From: Daniel Monk
Sent: 11 March 2026 11:50
To: Kwaku Bossman-Gyamera
Subject: HGY/2026/0343- Bruce Castle Park Lordship Lane London N17 8NU

SITE ACCESS & SET-UP PLAN:

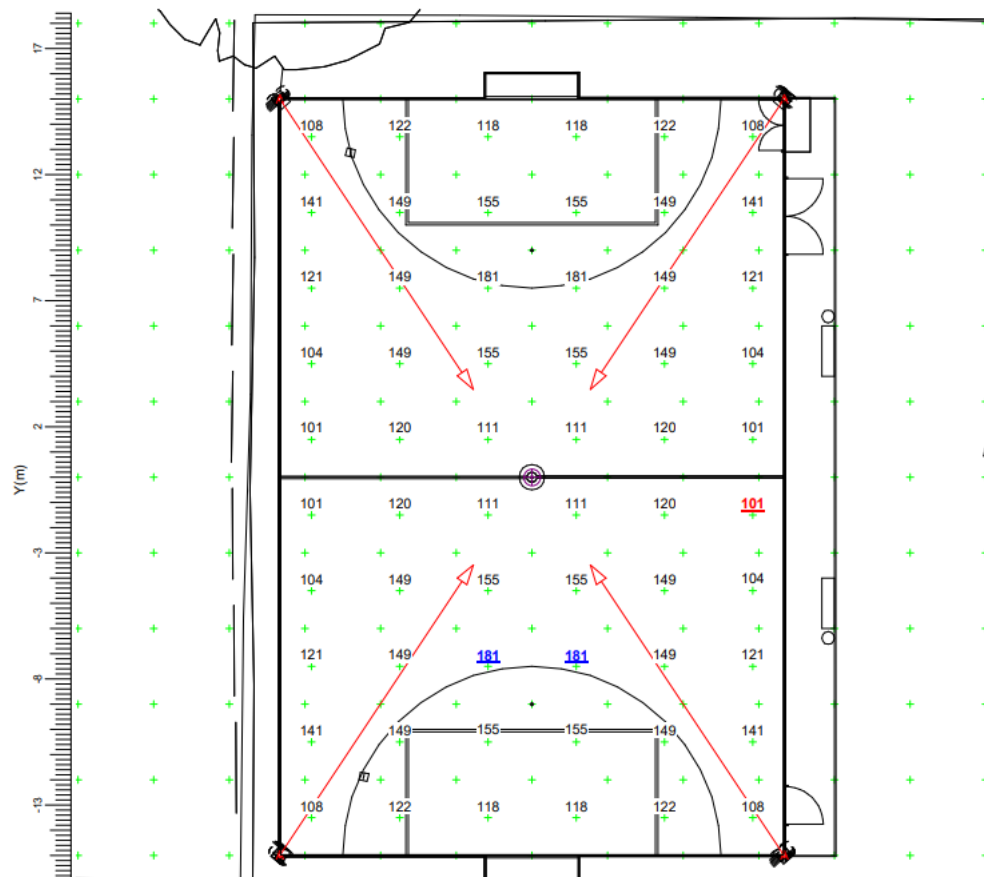
A tree protection plan clearly shows the protecting fence line, access, and egress from the site (see below).

Any storage, mixing, or plant machinery, will be required to be done on the hard stand.

3.1 Five-a-side Football-LED: Graphical Table

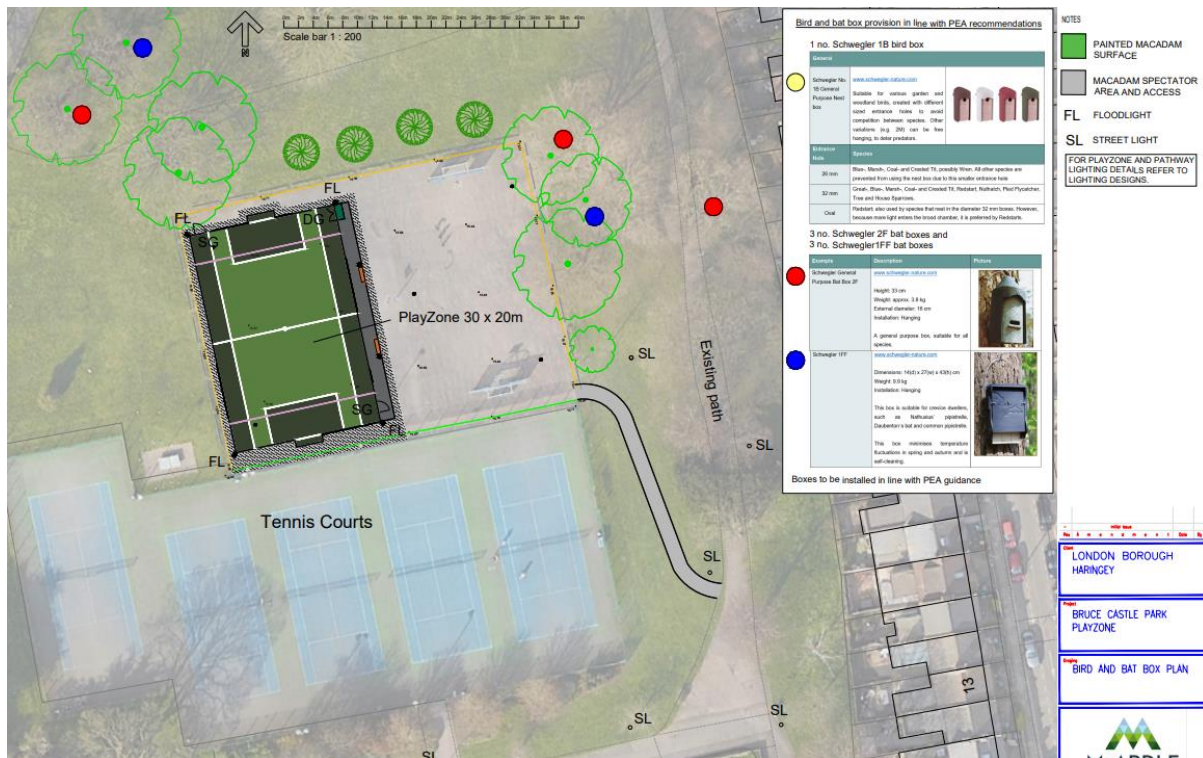
We will require method statements for the installation of the floodlighting and lighting that are within the root protection areas of the trees within the vicinity.
